Natural Resources Impacts “Towne Center at Shelter Ridge”

Prepared by Teresa Gallagher, Natural Resources Manager, Shelton, CT

April 5, 2016

Site Plans Reviewed: Dated March 22, 2016

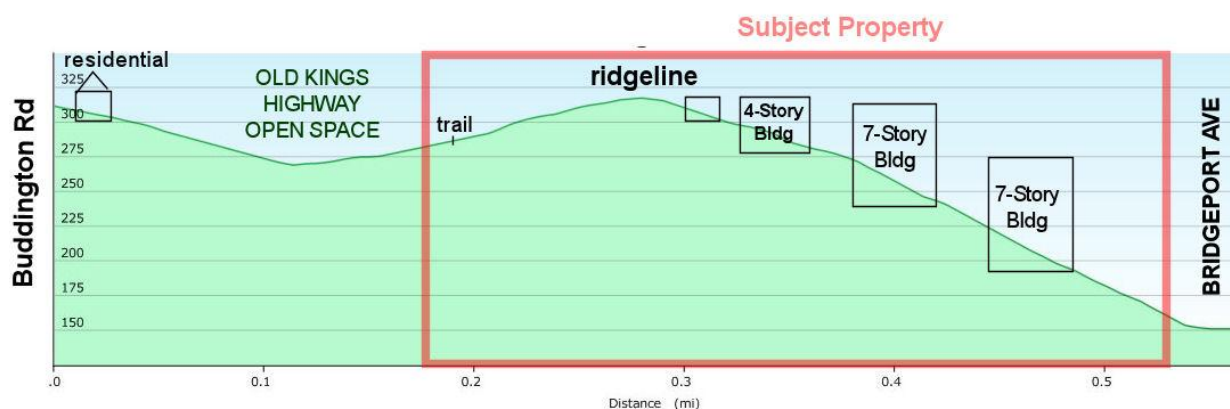
Instead of using the ridge to divide the greenway from the Bridgeport Avenue corridor, the proposed project includes a nine-story luxury apartment tower at the top of the ridge that would offer scenic views to prospective tenants. Additional buildings, drives, parking areas, and fill slopes are also depicted along the length of the ridgetop overlooking our high-value natural resources.

Using the ridgeline as a visual barrier between land uses.

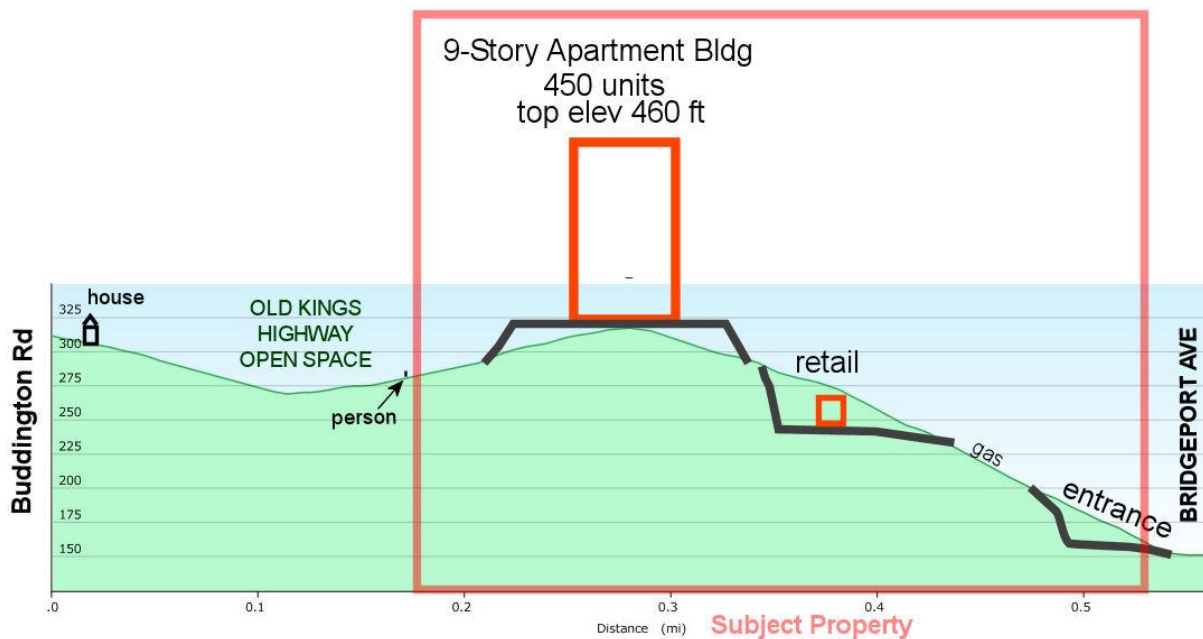
A comparison of how the site could be developed without visual impacts to the greenway or residential areas (top) to the proposed project (bottom):
